Appendix 3 - PSC Report Appendices for HGY.2023.0261

Appendix 2: Plans of the Proposed Scheme & Images

Stakeholder	Question/Comment	Response																
INTERNAL																		
LBH Carbon Management	<p>Carbon Management Response 20/06/2023</p> <p>In preparing this consultation response, we have reviewed:</p> <ul style="list-style-type: none"> • Energy Statement (BQ-WSP-XX-XX-ST-ES-0001-no_appendix_June2023) prepared by WSP (dated 13th June 2023) • GLA Carbon Emission reporting spreadsheet dated May 2023 • HGY-2023-0261 Berol Quarter N17 – May response to the comments from CMT • Noise and Vibration Assessment prepared by WSP (dated December 2022) • Relevant supporting documents. <p>1. Summary</p> <p>The development achieves a reduction of 72% carbon dioxide emissions. This increase in on-site savings is supported in principle. Some clarifications must be provided with regard to the Overheating Strategy. Appropriate planning conditions have been recommended to secure this which includes some outstanding requests for information.</p> <p>2. Energy Strategy</p> <p>The applicant has amended the carbon reduction values in the report and submitted the GLA's carbon emission reporti

Figure 6-12 Interim Car Parking Provision

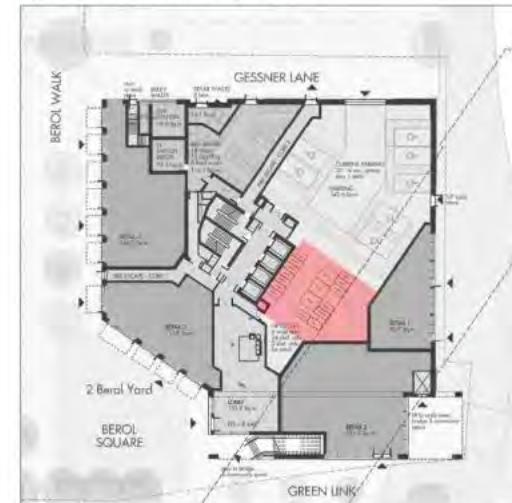
<p>disabled office employees / visitors. The required provision for each proposed use should be provided.</p> <p>c. Regarding Figure 6.12 and Figure 6.6 – Are the car parking spaces and the cycle parking both at ground floor levels or different levels?</p> <p>d. Regarding provision of Club bays, the current proposals are significantly different from those previously considered under Planning Ref: HGY/2017/2044. The TAR should assess / review the existing and committed demands for car club vehicles and demonstrate adequacy of provision of car club vehicles / capacity, to service the cumulative demands including from additional residential development proposals. A detailed proposal will be required.</p> <p>Regards,</p> <p>Shreekant Patel</p> <p>---</p> <p>Tuesday, March 21, 2023 4:26 PM</p> <p>Transport comments are as follows:</p> <ul style="list-style-type: none">a. The site has excellent public transport accessibility (PTAL=6a) and is located within a CPZ.b. The proposals are for the refurbishment of Berol House to provide 5209m² GEA Office use and 714m² GEA retail/commercial use. In addition, the proposals includes development of 2 Berol Yard to provide 210 residential units, 706m² retail / commercial use and 161m² community use space.c. The proposal includes cycle parking provision for 48 long-stay and 30 short-stay cycle parking spaces for Berol House and 380 long-stay plus 24 short-stay spaces for 2 Berol Yard. The layout of cycle parking does not meet LCDS standards for aisle widths adjacent to two-tiered cycle parking. Revised submission of detailed

<p>cycle parking layout with dimensioned plans that complies with LCDS, are required.</p> <p>d. The proposals for 2 Berol Yard will be car free except for provision for 'Blue Badge' car parking. This will initially include 3% provision for 6 'Blue Badge' holder parking spaces required for the residential units and one space for retail use. London Plan requirement for 10% of dwellings to be accessible and have parking spaces is not subject to reduction by reference to data from other sites. A parking management plan will be required to set out how this level of provision will be provided.</p> <p>The proposals for Berol House will include provision for one Blue Badge parking space. However, there will be 30 standard car parking spaces retained for existing tenants with contractual rights.</p> <p>The provision of one 'Blue Badge' parking space for the commercial use (5209m² GEA) is not considered adequate. Further detailed assessment is required using number of employees / multiple occupiers and statistics of percentage of working age people with 'Blue Badge' permits.</p> <p>Clarification is required regarding the overlaps in layout of interim retained 30 car parking in Fig.6.12, the cycle parking illustrate at Figure 6.6 and the vehicular swept path for a refuse vehicle, below.</p>
